Southern California Edison Company

Subject: Docket Nos. 50-361 and 50-362
San Onofre Nuclear Generating Station
Units 2&3

RESPONSES TO NRC QUESTIONS
 SAN ONOFRE NUCLEAR GENERATING STATION
 UNITS 2 AND 3

SAN ONOFRE NUCLEAR GENERATING STATION
Units 2 & 3
 WIDE RANGE EFFLUENT MONITOR
 CONFIGURATION FOR CONTAINMENT
 PURGE FOLLOWING POSTULATED
 UNIT 2 ACCIDENT
 Figure 321.12-2

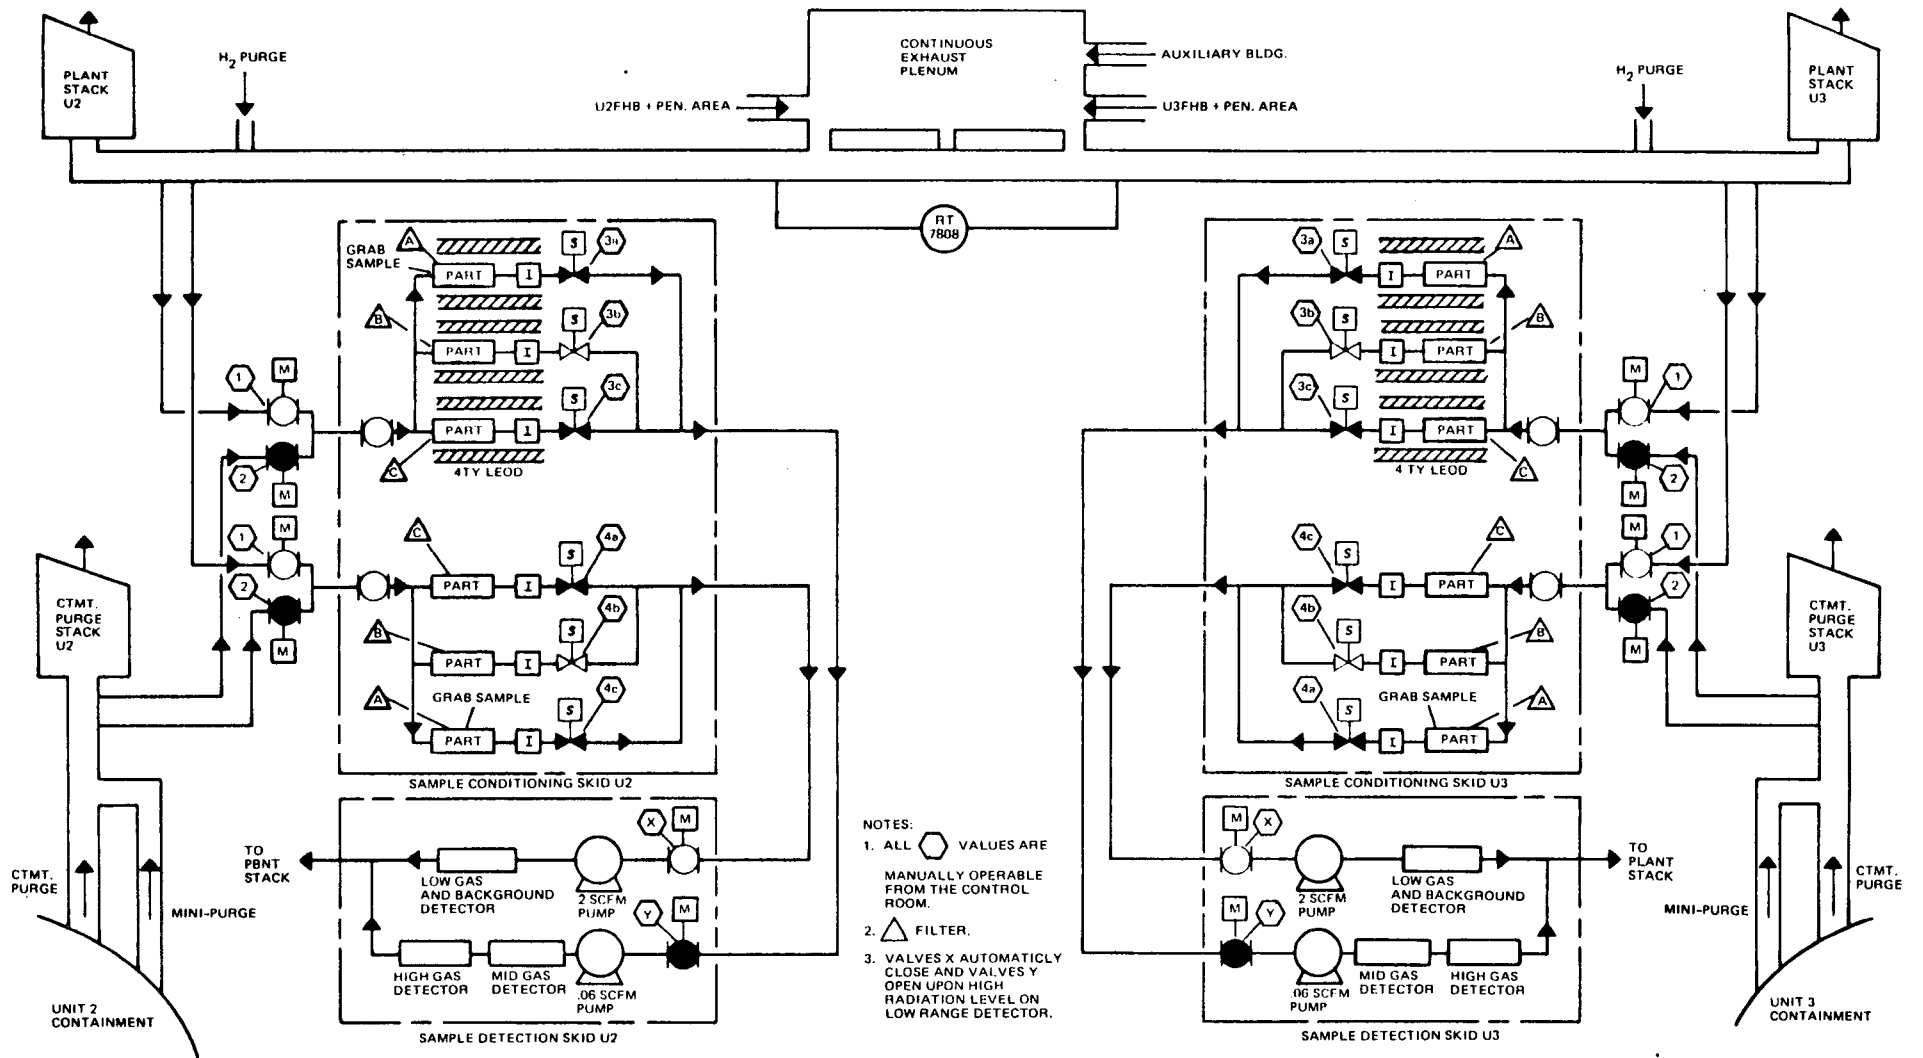
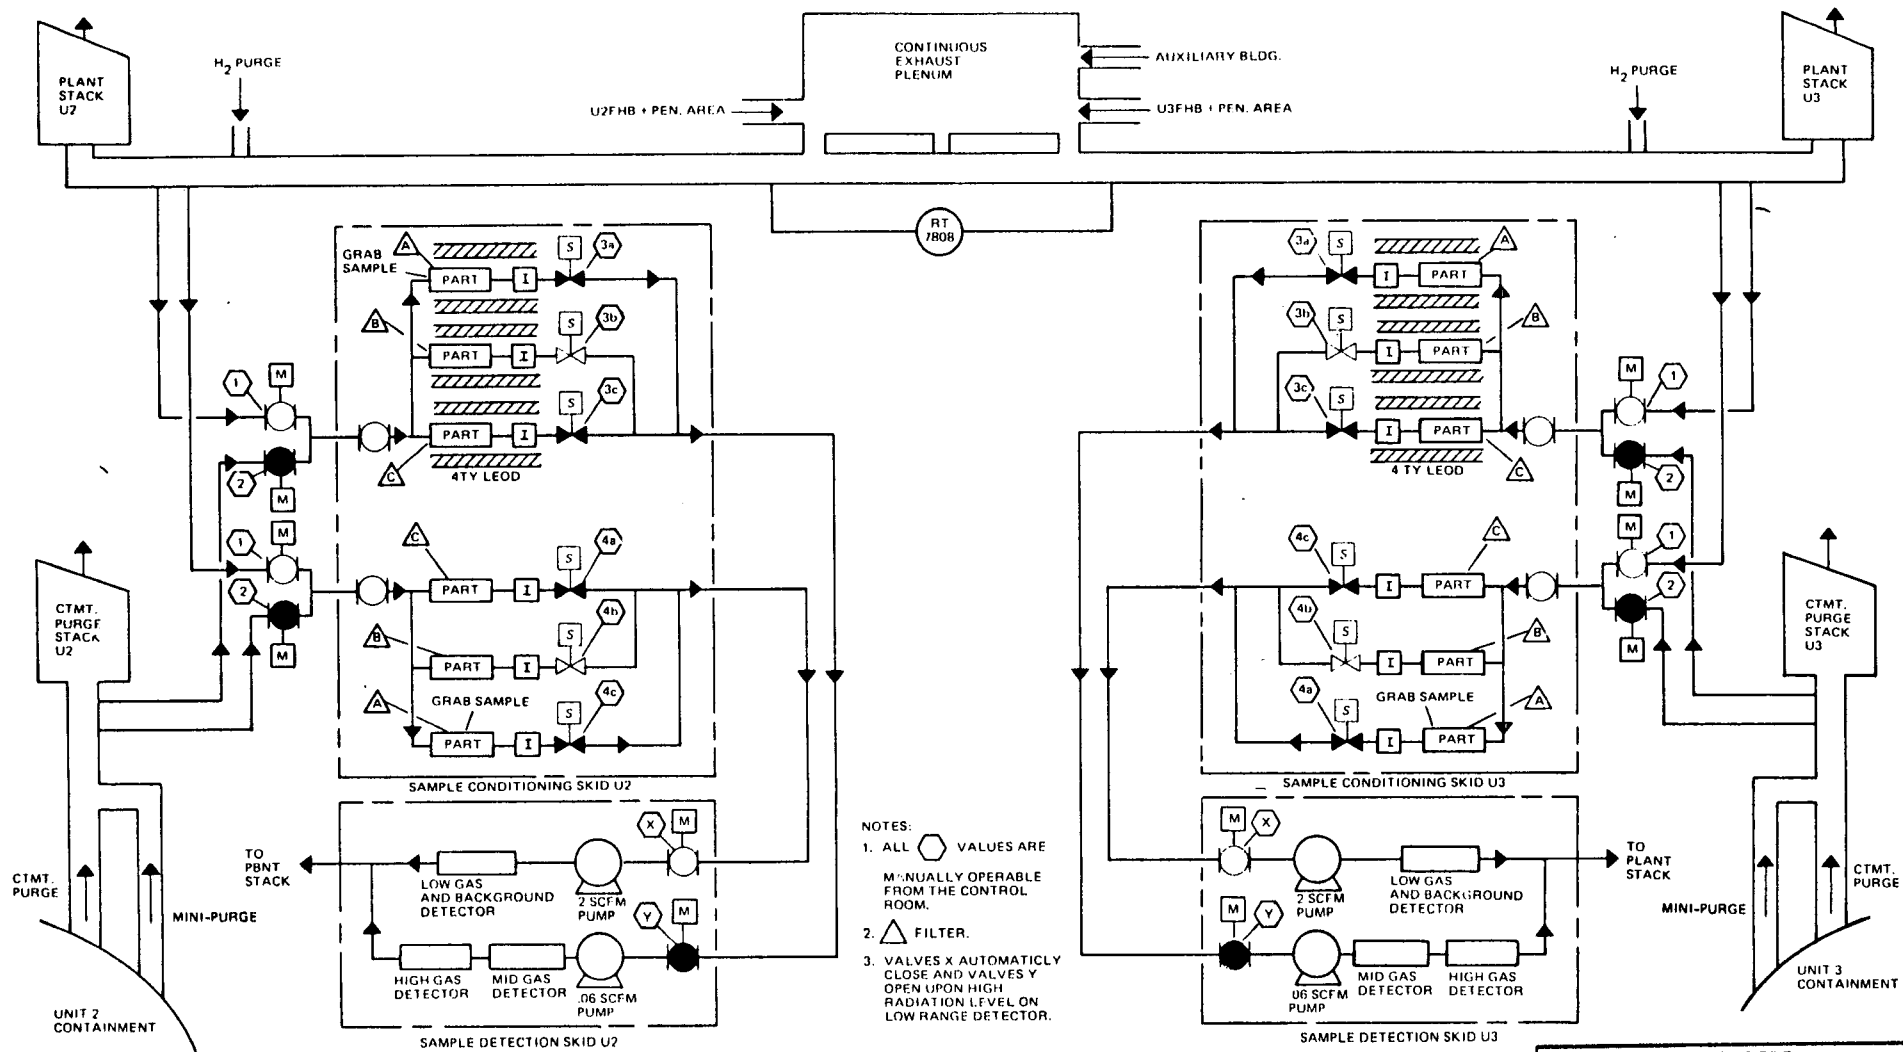
In your submittal, you have stated that the effluent monitors will provide continuous recording of the effluent in the control room. It is our position that this should be done for each separate release pathway. Explain how you can accomplish this with a single monitor which can switch back and forth between continuous vent and containment purge exhausts.

The purpose of the wide range effluent monitor is to provide an expanded range for monitoring radiological effluents following a postulated accident. During normal operation both the Unit 2 and Unit 3 monitors will be aligned to sample the plant vent stack as shown on figure 321.12-1. With this alignment, one of the filters (c) for both the low and high range flow paths will be assigned to the plant vent stack.

For a postulated accident in Unit 2, the Unit 2 containment purge system will be isolated as described in FSAR subsection 6.2.4. The operator using radiological information provided by the high range incontainment monitors (FSAR subsection 12.3.4), containment airborne monitors (FSAR paragraph 11.5.2.1.4.5), emergency radiation monitoring system (FSAR subsection 12.3.4) and postaccident sample system (FSAR subsection 9.3.6) would decide when to initiate containment purge. Prior to purging the containment, the wide range effluent monitors would be aligned as shown on figure 321.122.

With the post-accident configuration as shown on figure 321.122, the Unit 3 wide range effluent monitor would be sampling from the plant stack. Because of the common continuous exhaust plenum the radiation release through the Unit 3 plant stack would be one-half the total plant release.

SAN ONOFRE NUCLEAR GENERATING STATION Units 2 & 3
WIDE RANGE EFFLUENT MONITOR FILTER EXTERNAL DOSE
Figure 321.18-2

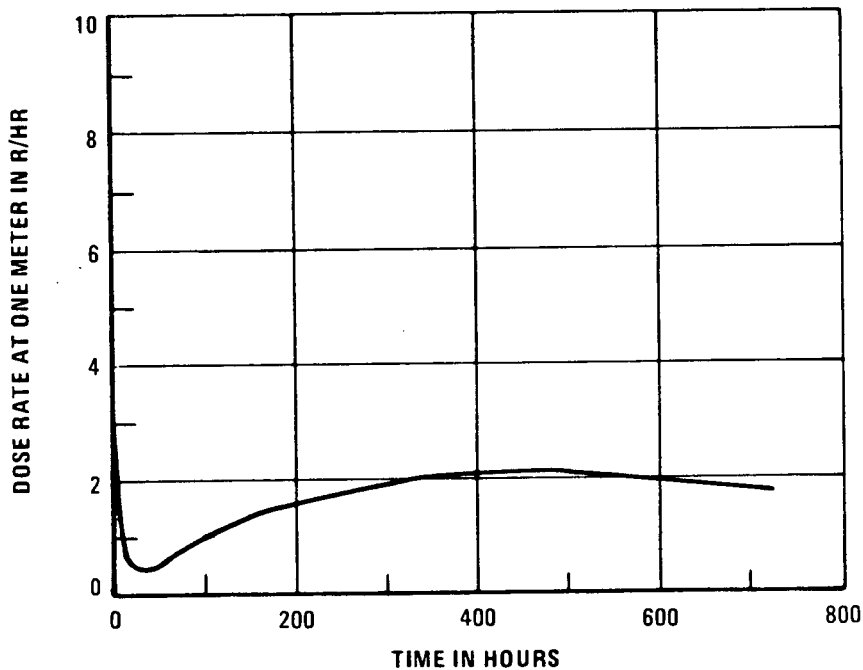
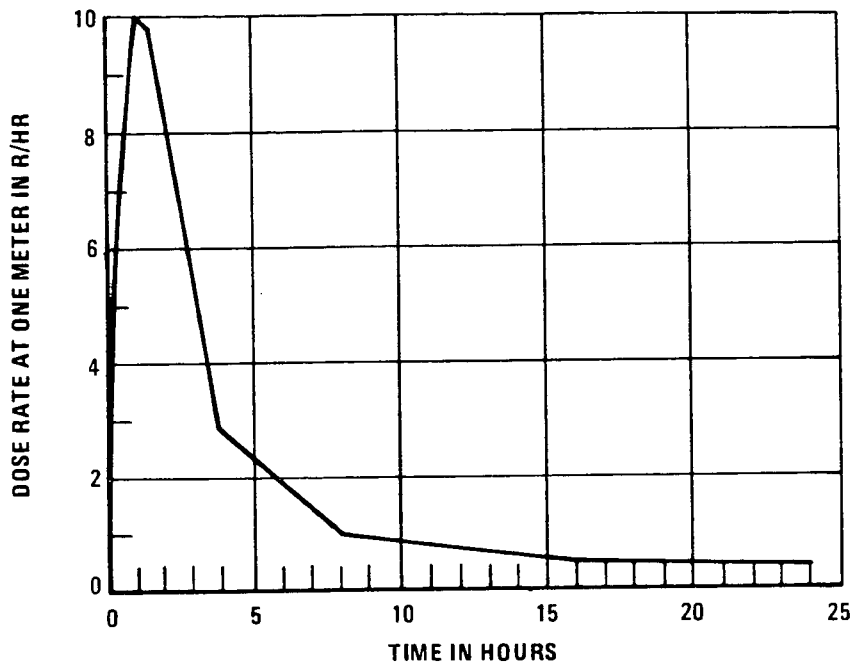
Will the 4" lead shield that surrounds the filters be equivalent to the basis set forth for shielding envelope by NRC in its September 5 letter to all licensees and applicants on "Preliminary Clarification of TMI Action Plan Requirements"?

The 4π lead shield surrounding the wide range effluent monitor high range particulate and iodine filters is 2 inches thick. The design basis for the filter shielding is $10^5 \mu\text{Ci/cc}$ of noble gas and $10^2 \mu\text{Ci/cc}$ iodines leaving the stack at the design flowrate. The filter is modeled as a flow thru system assuming a 99% particulate filter efficiency and 95% silver zeolite efficiency. The model considers buildup of daughter products, as well as the actual gamma energies for each isotope. Figure 321.18-1 shows the buildup of activity on the shielded filters. Figure 321.18-2 shows the dose rate versus time for these filters.

Figure 5-4

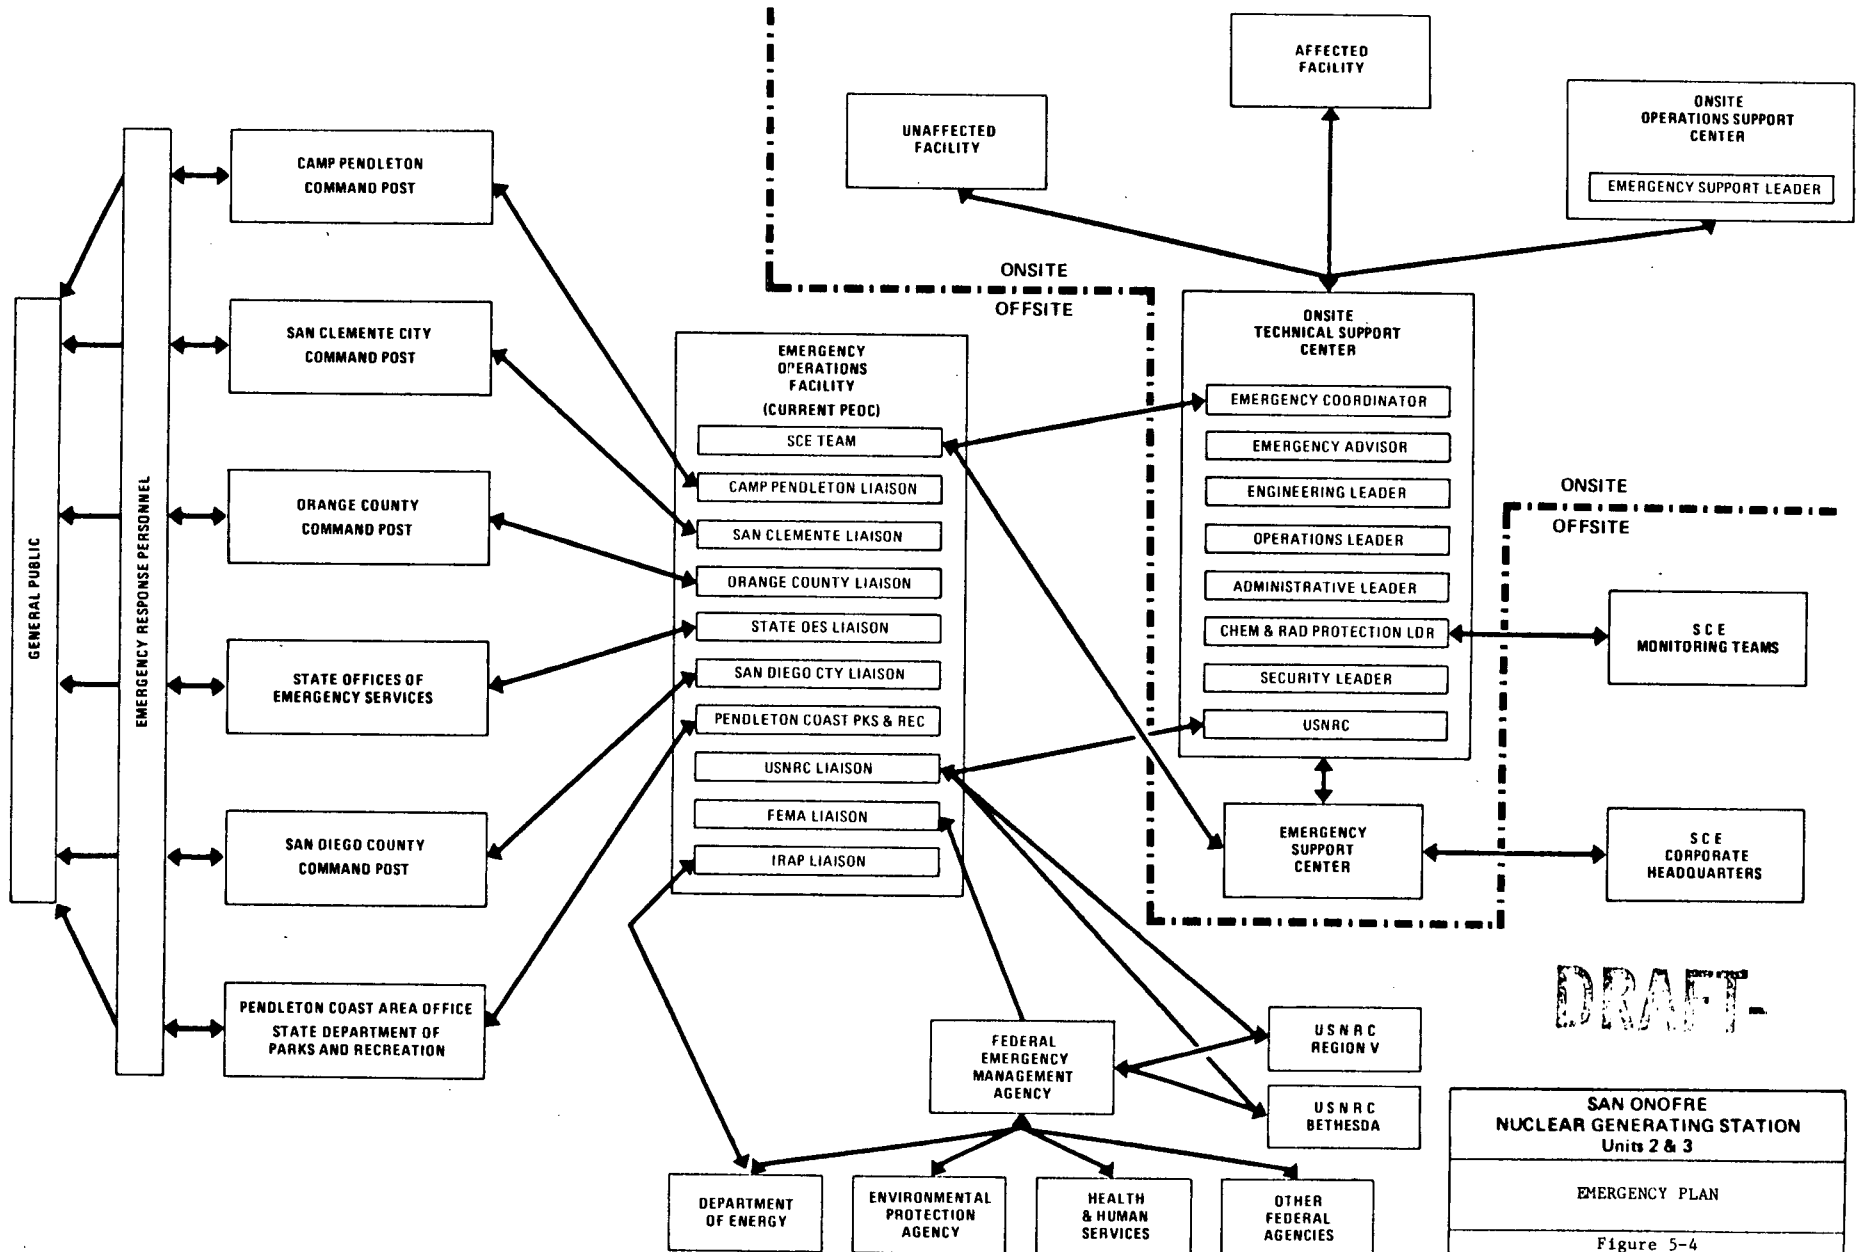
Illustrate the interrelationships among the licensee and other involved organizations (State, local governments, DOE, laboratories etc.).

The present Figure 5.4 in the Emergency Plan will be replaced with the attached draft Figure 5.4. A finished version of this figure will be incorporated into the revised Emergency Plan. This figure will provide the information required above.
